**Public Input No. 3085, Assigned to Code-Making
Panel 1, Refer to Code-Making Panels 2 - 18**

Public Input No. 3085-NFPA 70-2023 [Global Input]

Photo 1 – Common Alternate Energy Installation

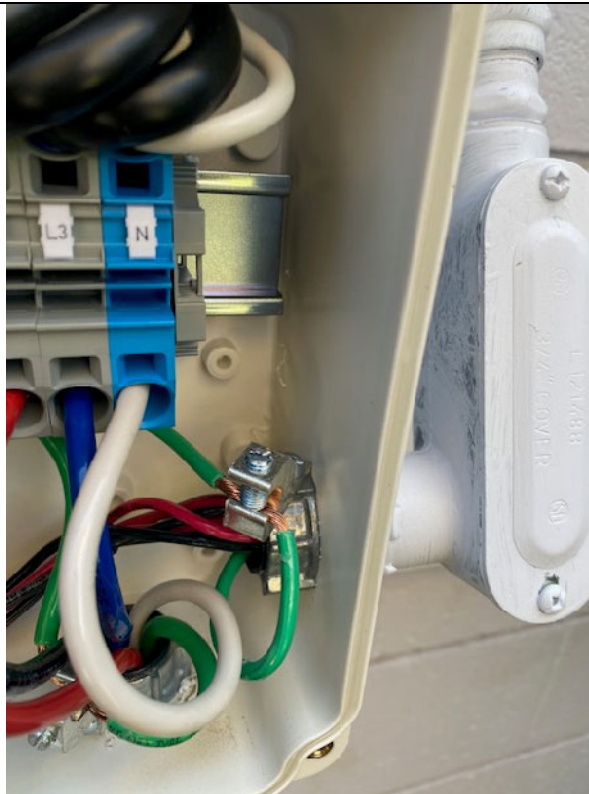
A public input has been submitted to 250.109 to establish grounding and bonding requirements applicable to all nonmetallic boxes and enclosures. Article 250 is the proper place for these provisions. This companion public input is submitted to correlate these changes. The two exceptions presently provided in 314.3 are no longer needed with the addition of the provisions of 250.109(B). Exception 1 has been revised to point the user to 250.109(B) and exceptions where metallic wiring methods are allowed for nonmetallic boxes. A copy of the proposed changed to 250.109 are attached for reference.

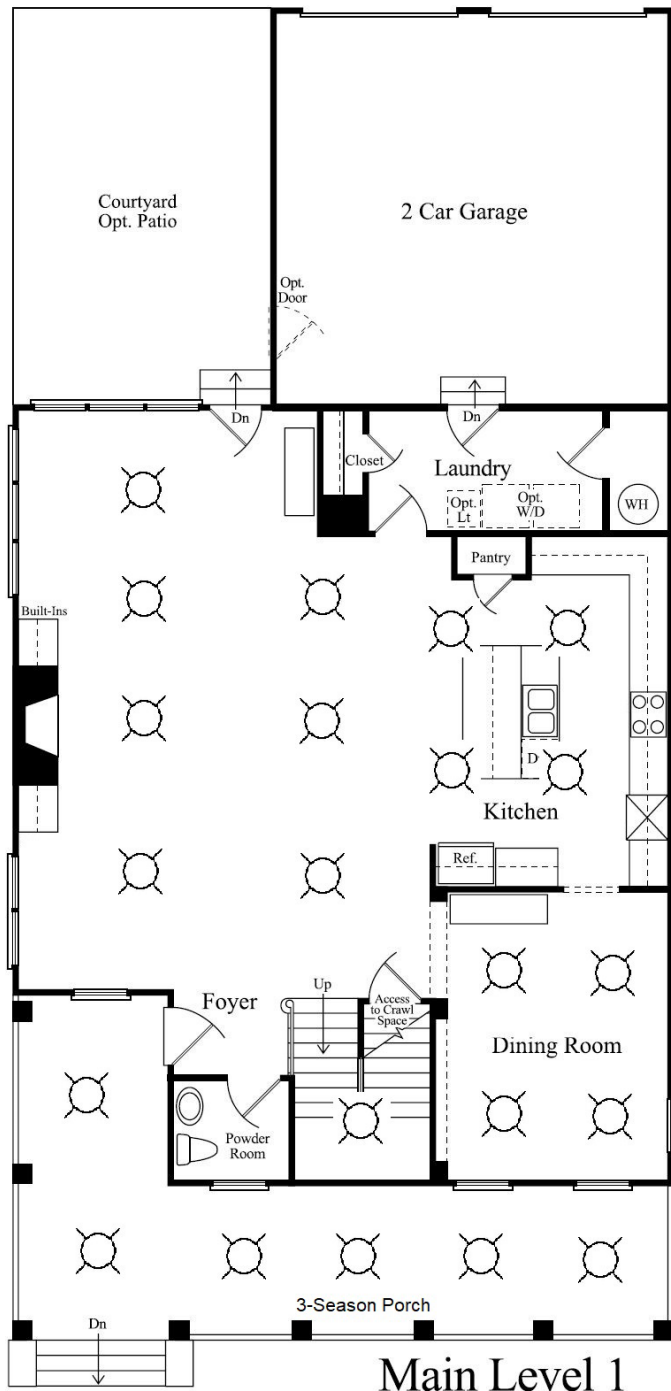
Electricians who work in PA, NJ and DE brought this to our attention. They are installing fan-rated boxes around the kitchen and in off-center lighting locations around various rooms based as a result of the electrical inspector’s interpretation at a cost of \$15-\$20 per location. A home being built with 20 or so “acceptable” locations is now paying an additional \$400 which is being passed along to the homeowner with no added benefit.

Below is a sample plan with 22 ceiling lights laid out in the living spaces. According to the current language, it seems that all 22 locations could be considered “acceptable for the installation of a ceiling-suspended (paddle) fan.” Therefore, the requirements of 314.27(C) would apply. I believe this is overly restrictive based on the reasons given above. The proposed word “typical” may allow a broad interpretation, but, together with the informational note, it is less broad than the current wording.
